APPROVED MINUTES

May 19, 2011 Standards Committee Meeting

RE: Minutes for the May 19, 2011 Standards Committee Meeting

HANDOUTS TO GENERAL BUSINESS ITEM 2. SAFETY EDGE
500-R-XXXd SAFETY EDGE

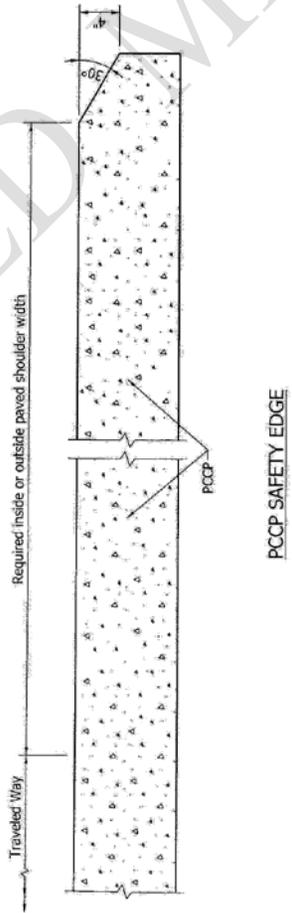
The paver shall be capable of constructing pavement edges in accordance with drawing 500-R-XXXd.

Forms shall be capable of constructing pavement edges in accordance with drawing 500-R-XXXd.

805-SGCF-03 SIGNAL PEDESTAL FOUNDATION TYPE A

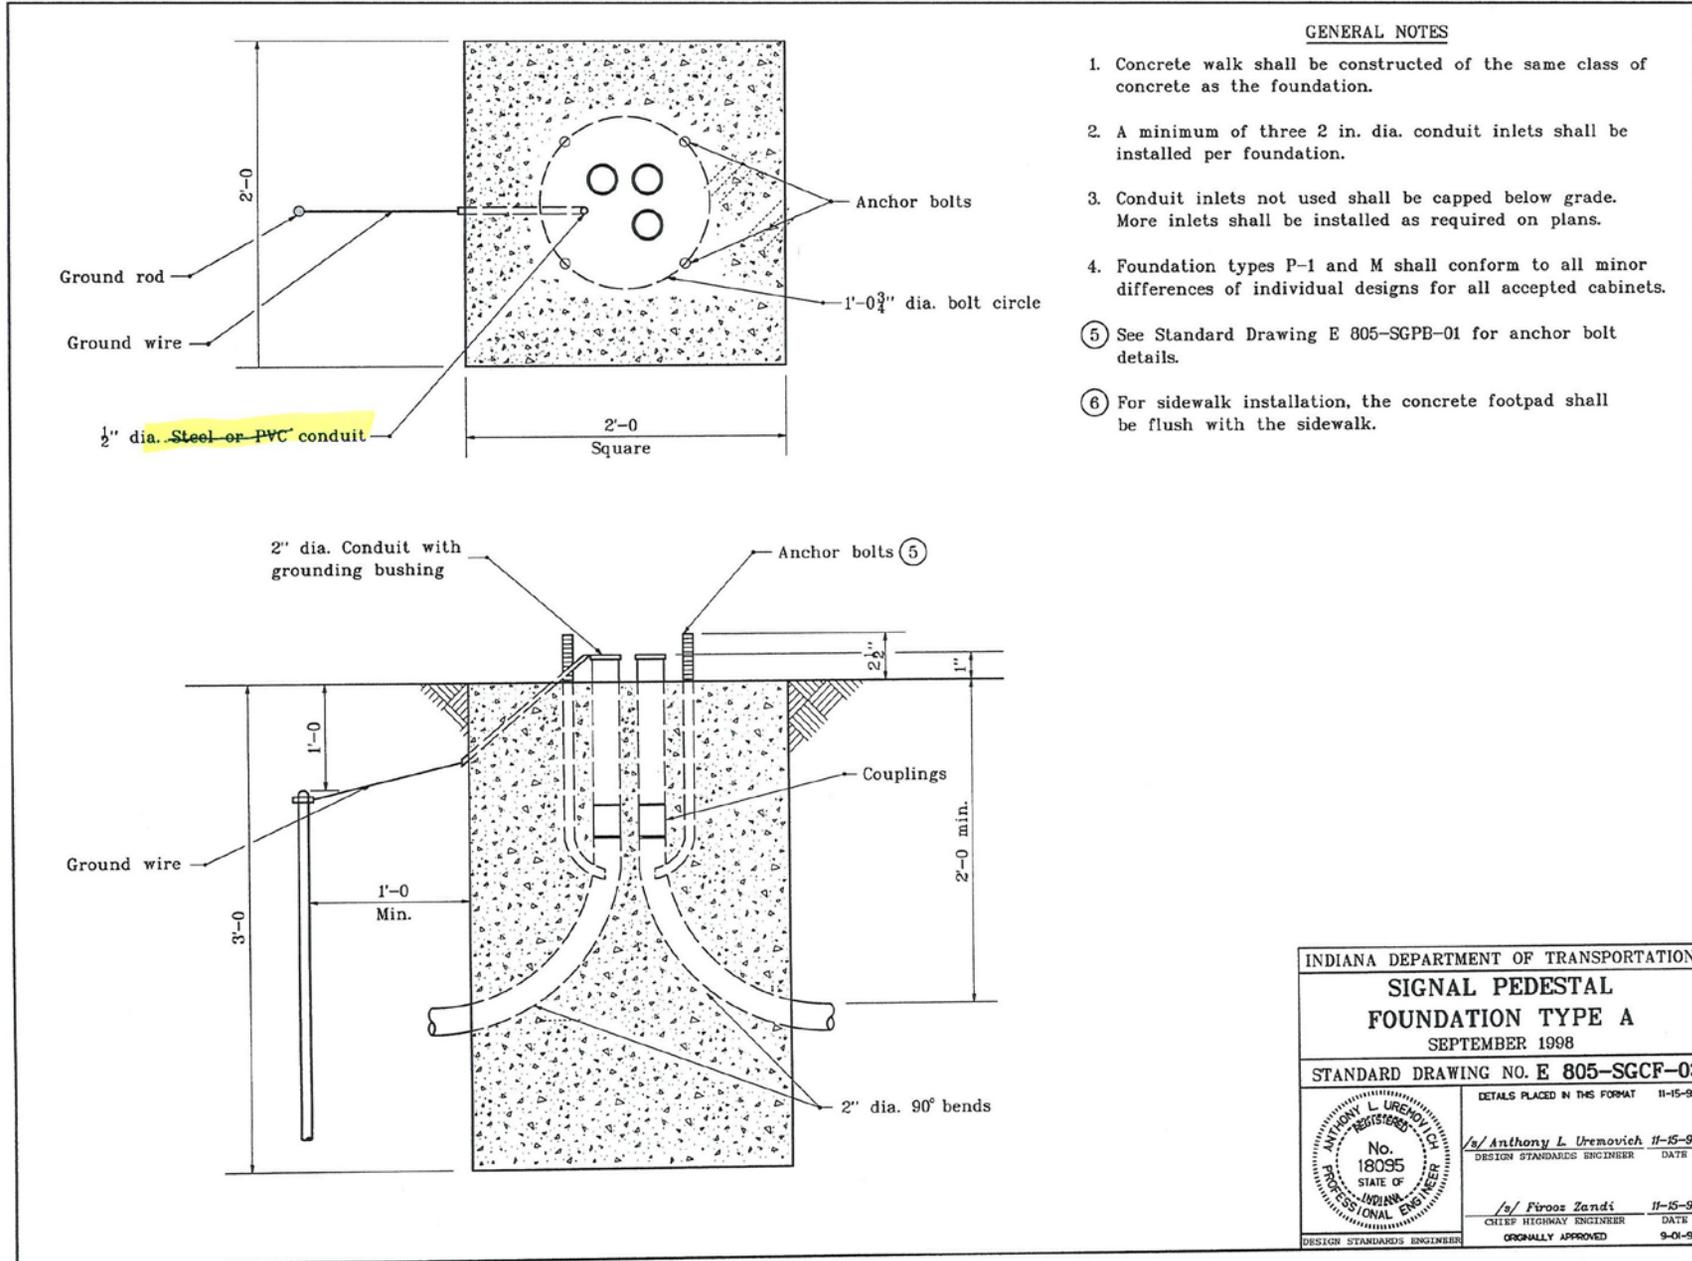
Mr. Boruff suggested to also revise standard drawings 805-SGCF-03, 805-SGCO-01 and 805-SGLI-01. The material references for the conduit will be taken out, to remain consistent with the proposed revisions to the standard drawings presented in the meeting agenda, and as shown attached to these meeting minutes.

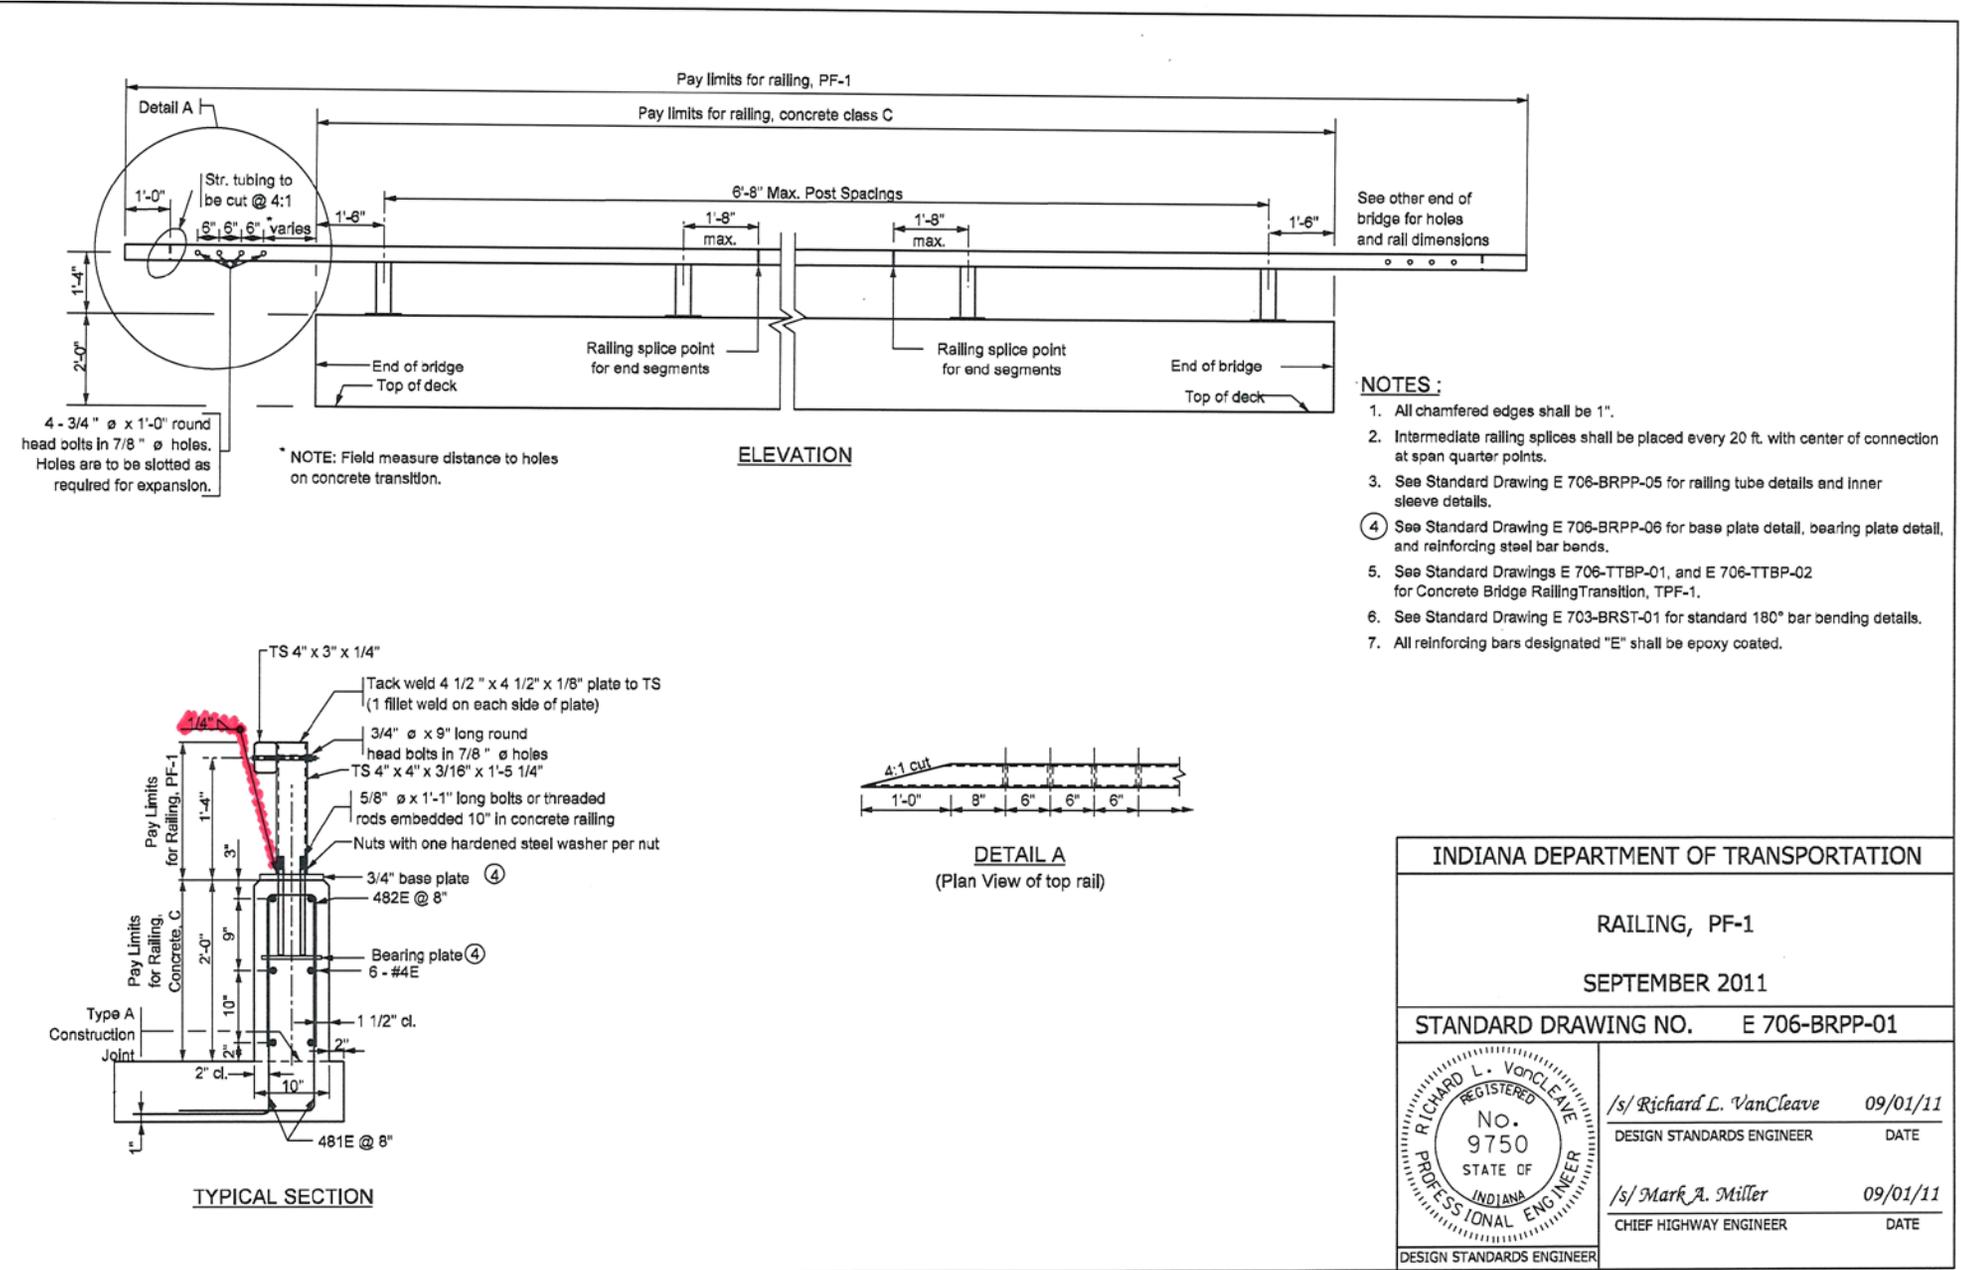
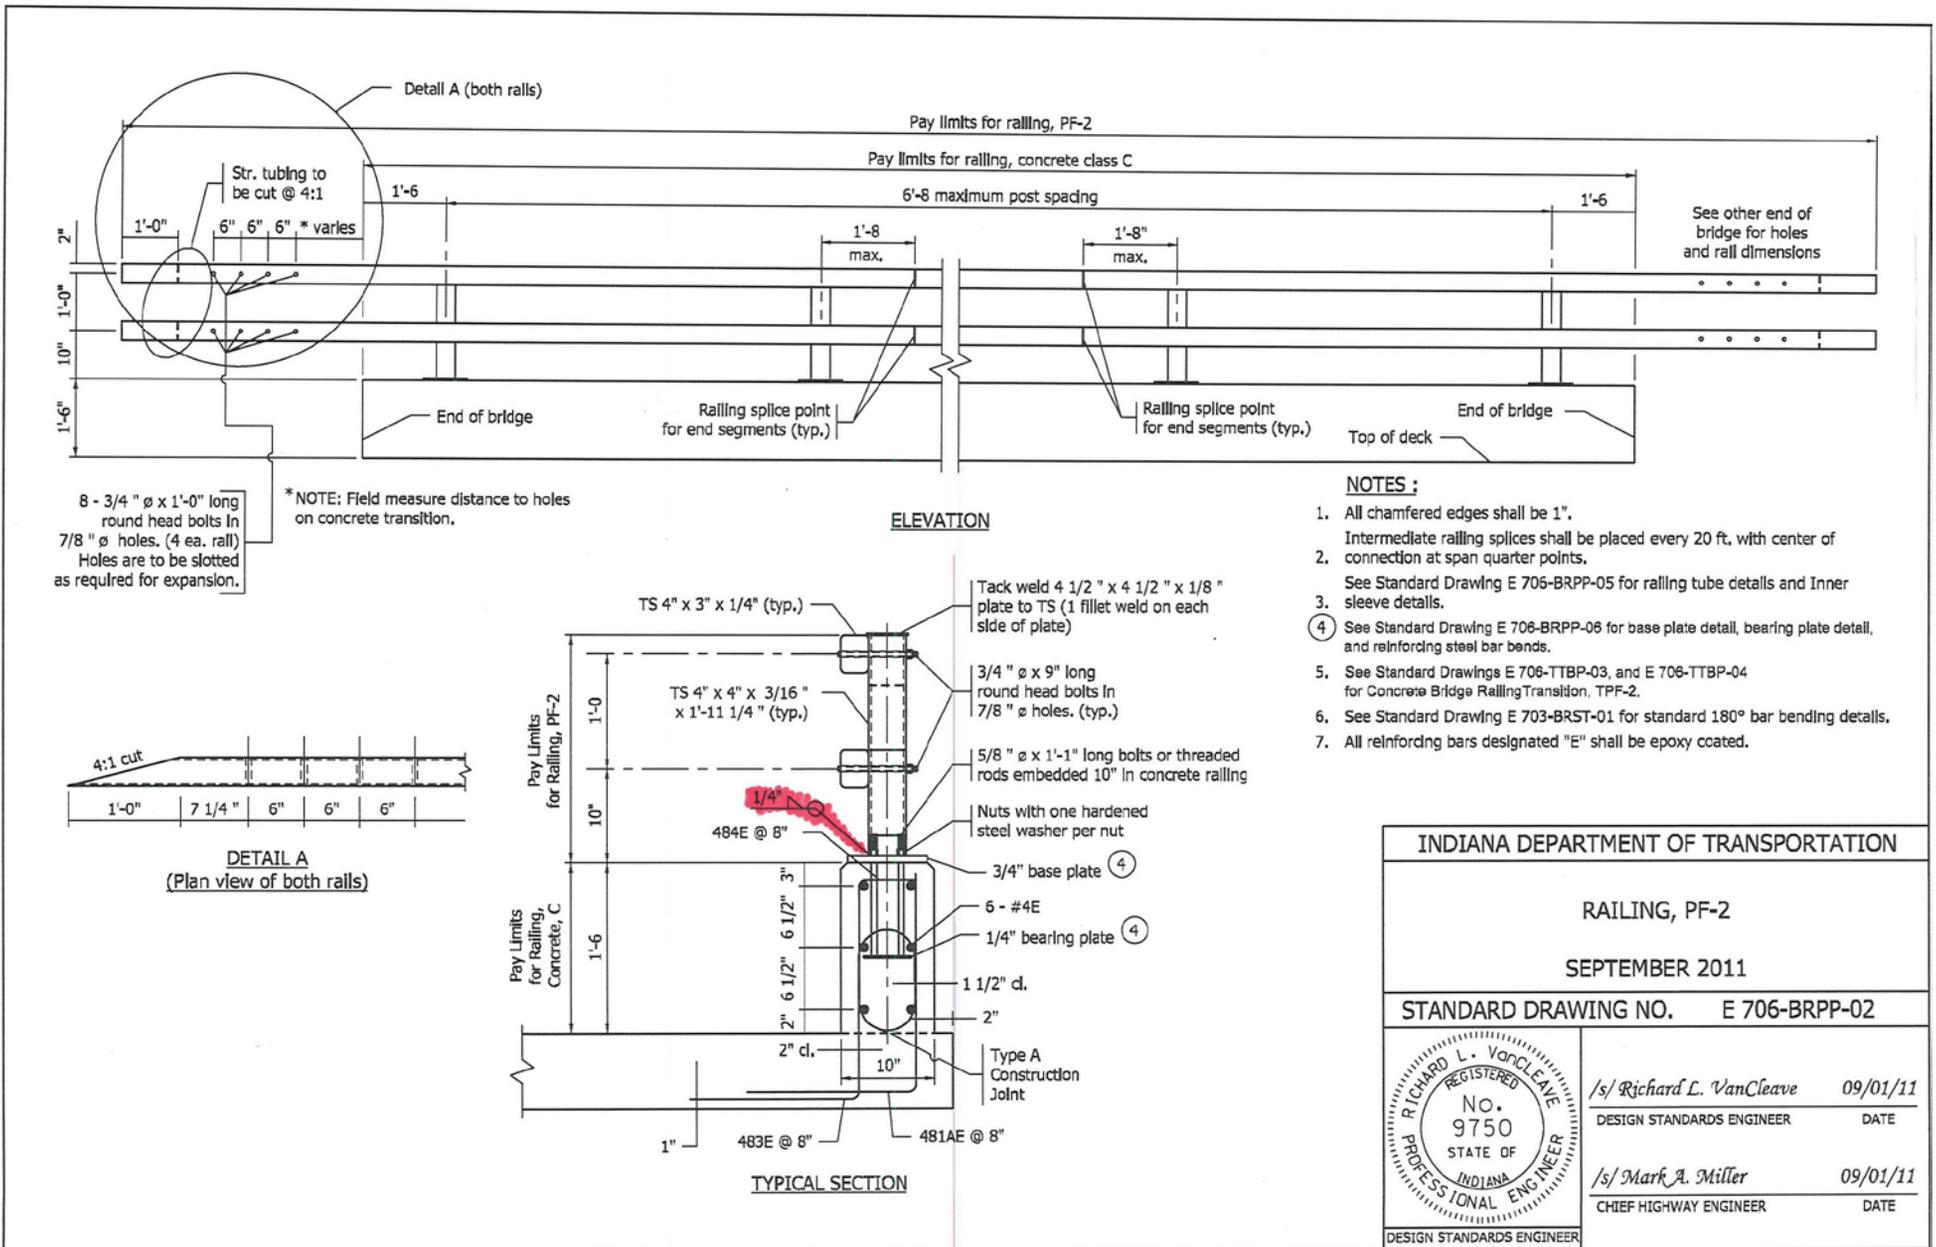
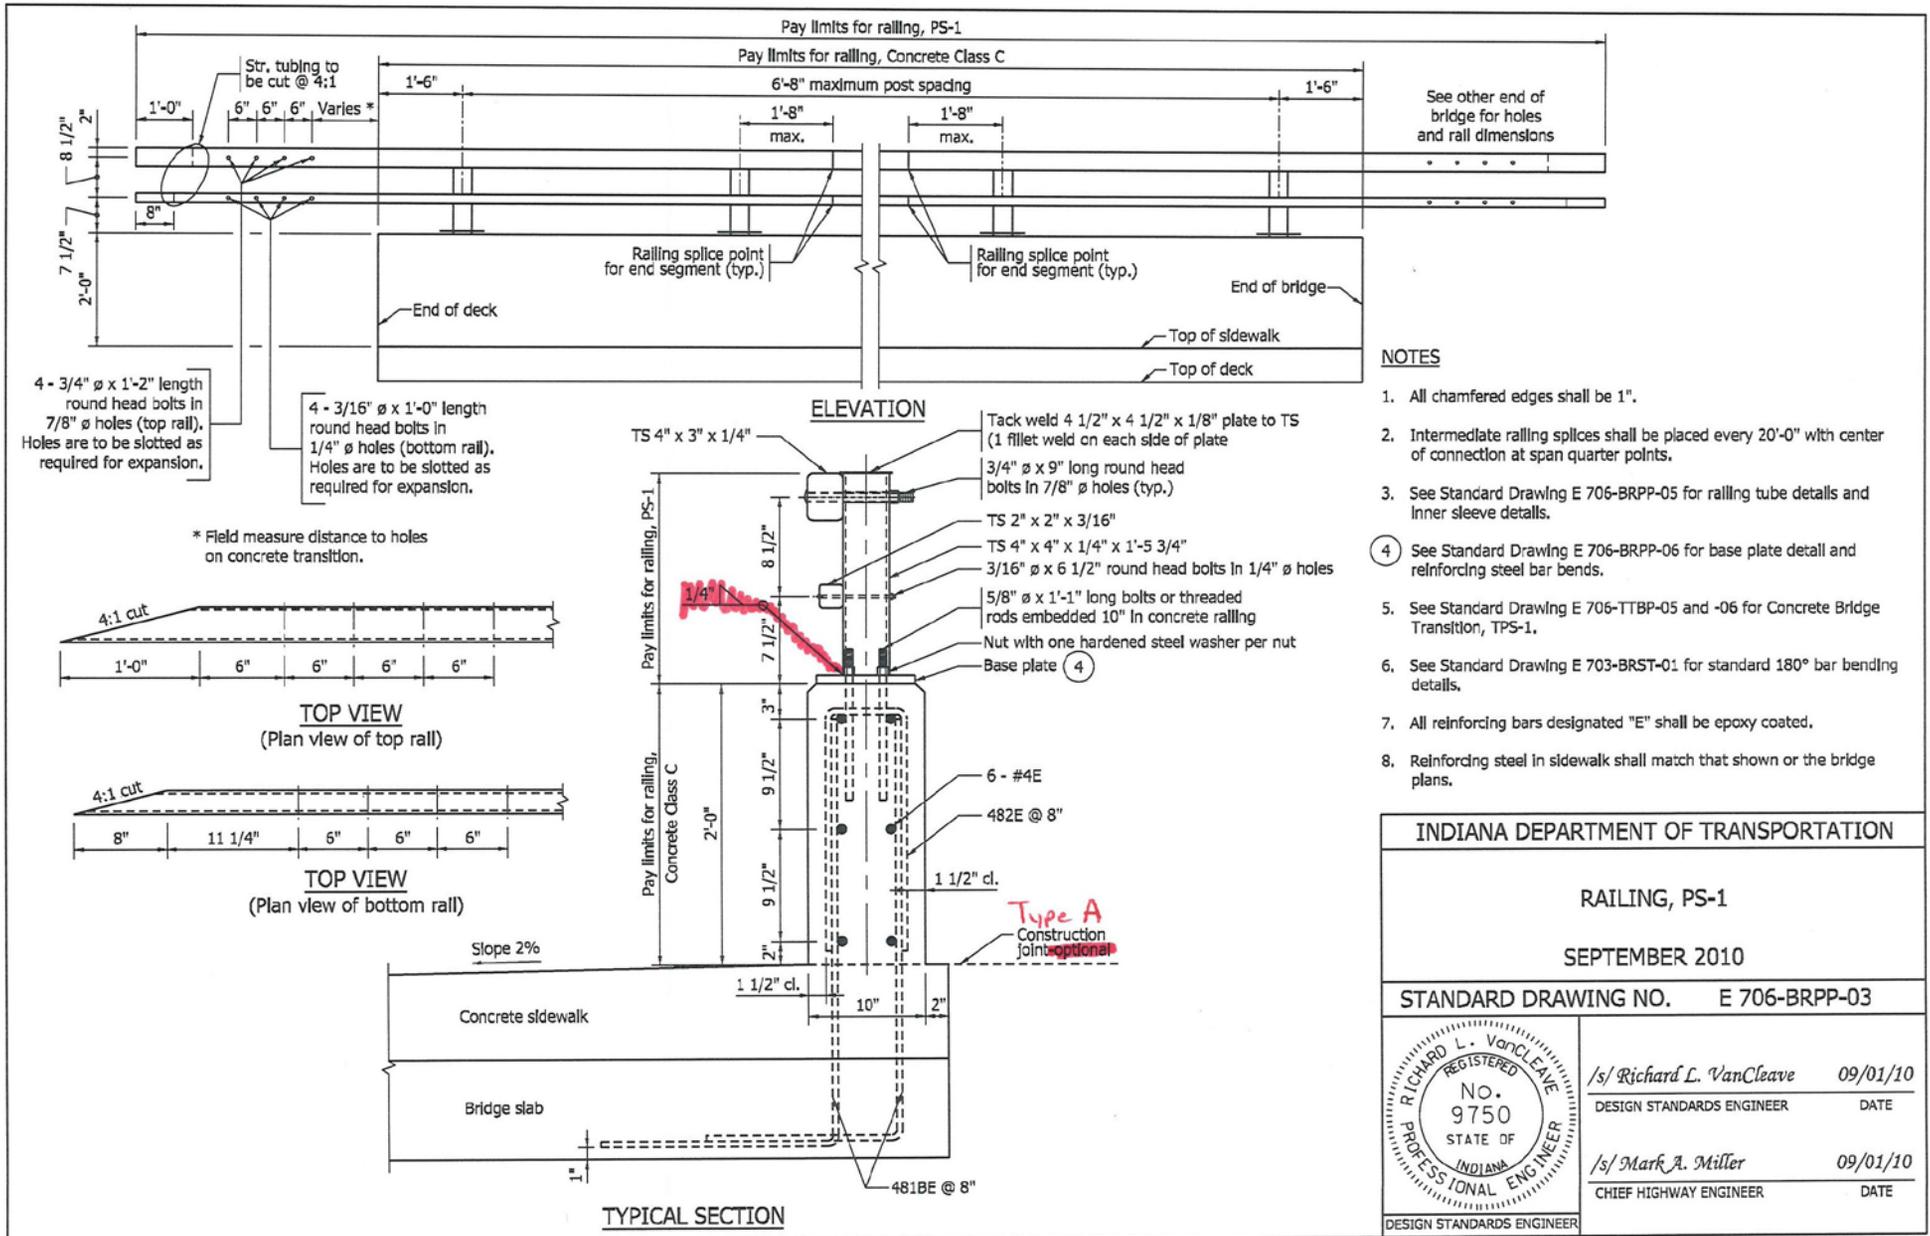
DISCUSSIONS: This item was introduced by Mr. Reilman, who explained that some discrepancies were found in the standard drawings regarding weld symbols and requirements. Further revisions are proposed to provide clarity, and were explained by Mr. Reilman.

PROPOSED SOLUTION: Show the welding requirements where necessary.
